**The following plan concept was submitted by Chuck Dowding.**

# Why is Elder Now w/simple ADA access is a good solution

Elder Now Plan to produce swimmable beach without foreclosing options

## Great Lakes Water Levels (1918–2022)

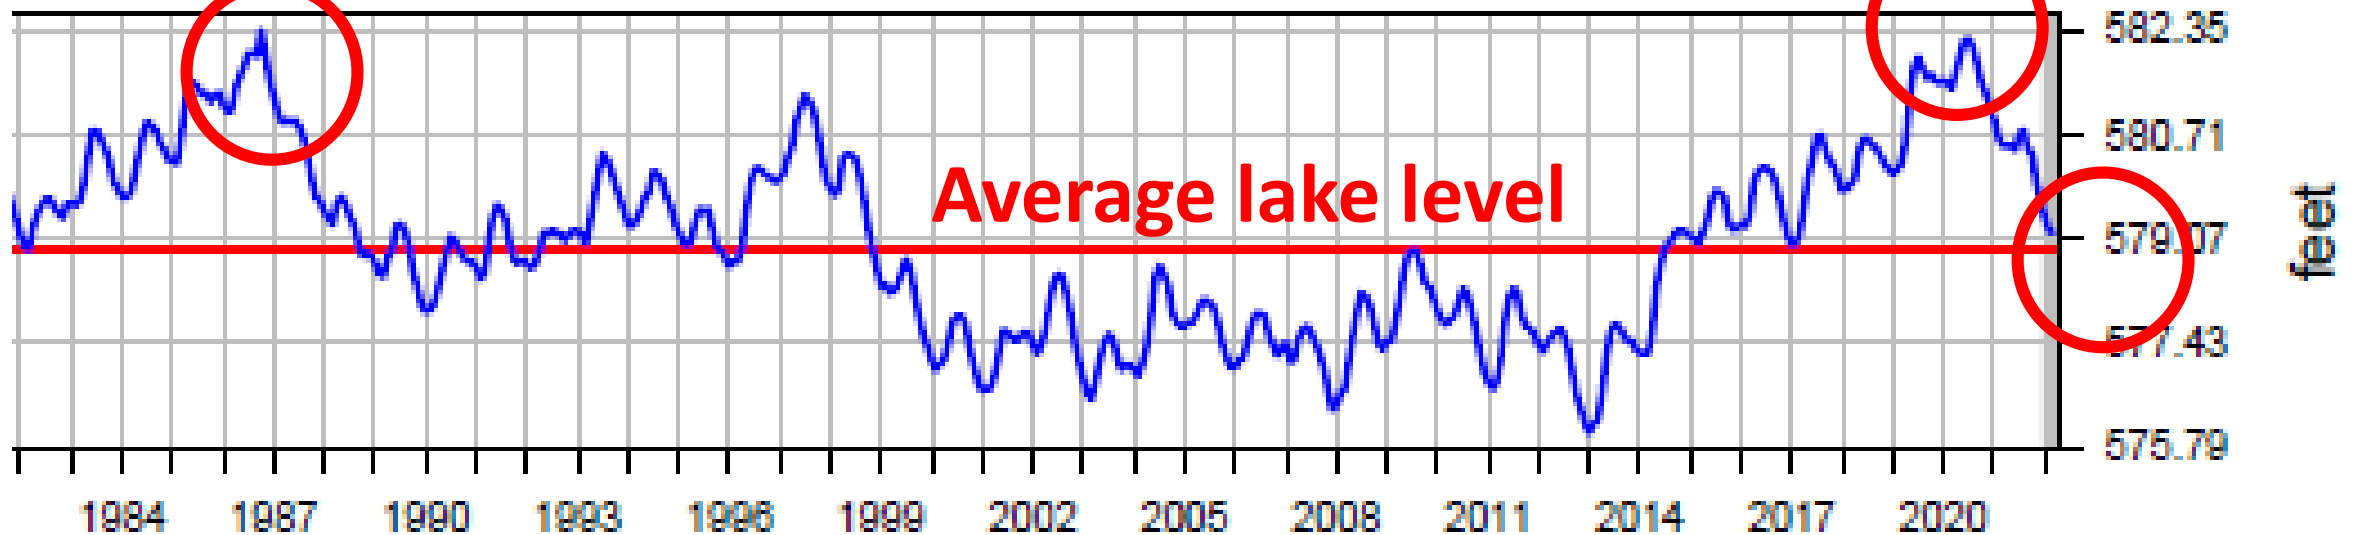
**There is less urgency than for Lloyd**

## Elder Beach looking North

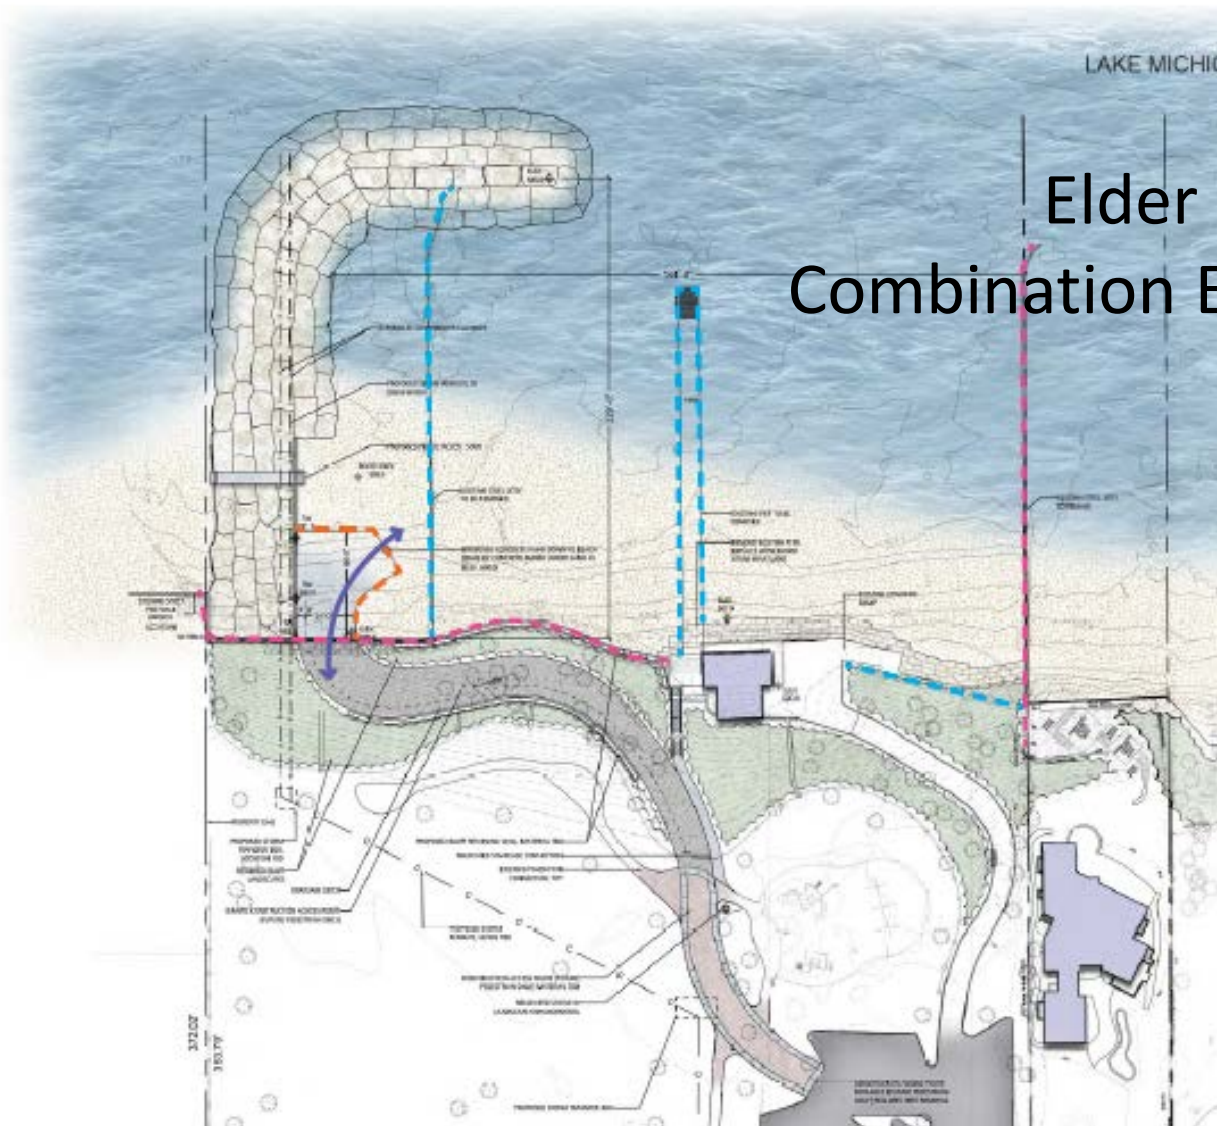
No need for stabilization of bluff  
1980's sheet piles and gabions show no signs of instability

**New outfall Pipe on lake bed w/out stone breakwater**

**Remove  
Pier housing present  
storm sewer outfall**

- Leave in place sheet pile groin at boundary between Elder/261 (elevation ~ 583) at southern end of 300 feet on drawing to left
- Build pollution reduction devices for Village storm sewer outfall already designed by Burke
- In surf zone, encase outfall pipe in sheet pile protection with maximum height of sheet piles equal to present groin height of 583.
- Beyond surf zone bury pipe in clay trench  
200 ft out as presently planned or  
350 ft to extend to deeper water
- Remove existing north sheet pile groin
- Demolish pier housing present outfall pipe in middle of beach
- Now have some 400 ft beach to repurpose according to new post Lloyd use patterns
- Add beach sand if necessary
- Go swimming
- Add stone breakwater if necessary
- Add ramp later if necessary

Combination Centennial Option 1 and 2

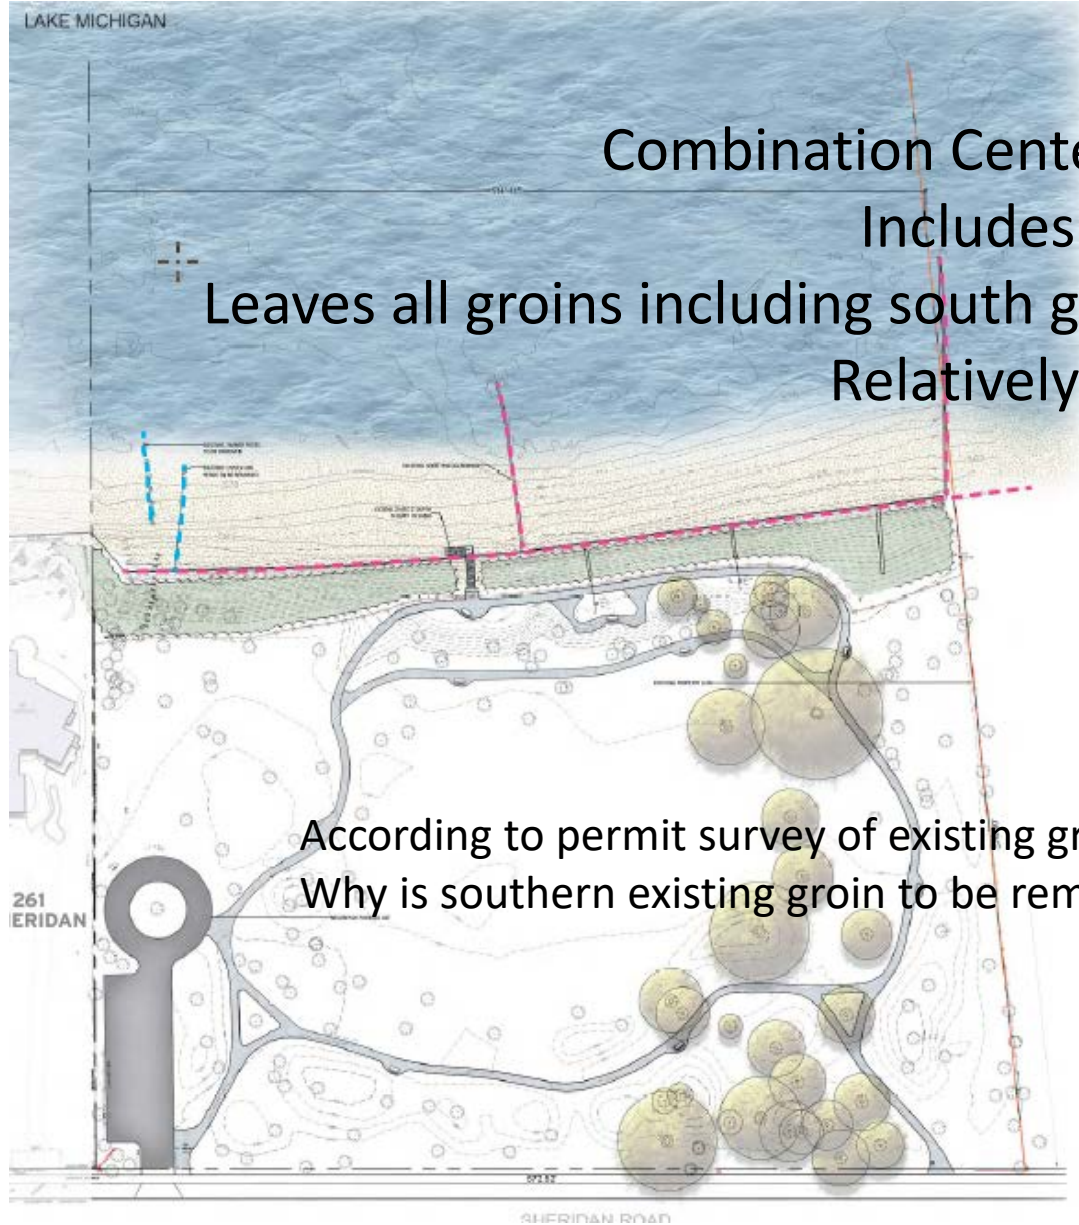
Leaves all groins including south groin to maintain 583 beach template

According to permit survey of existing groins --- both the 2 red and 1 blue exist

Why is southern existing groin to be removed in option 2?

Soft Costs				\$175,000.00	\$175,000.00		
Thotal hard and soft costs				\$4,561,600.00	\$1,467,000.00		
Contingency (15%)				\$657,900.00	\$193,800.00		
Total				\$5,219,500.00	\$1,660,800.00		
Missing Considerations							
Access roadway not on these plans
